Access Compliance Report

Public Rights-of-Way

Intersection ID: 11423	Main Street: S SUMMIT_AV	Cross Street: W 4TH_ST_EXT	Location: N
ADA ID: 575E7A49F57D	Ramp Type: Directional1	Initial Pass/Fail: Fail	Overall Compliance: No
		Severity Score: 12.5

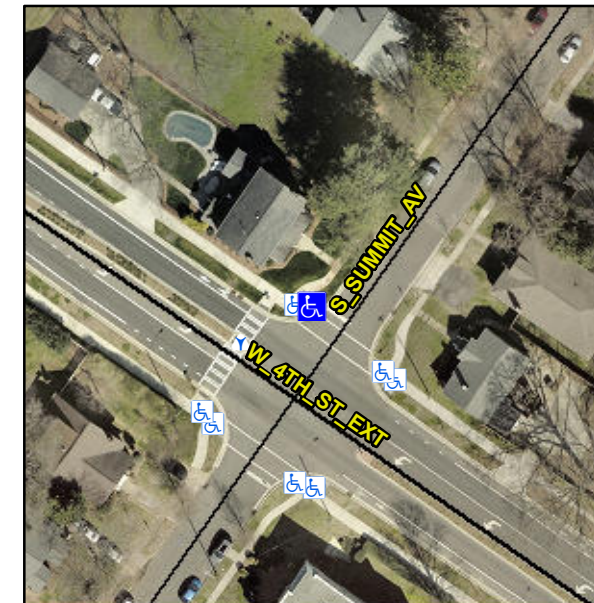
Possible Solutions:

Remove & Replace Entire Ramp.

PROW/ADA:

R304.2.2
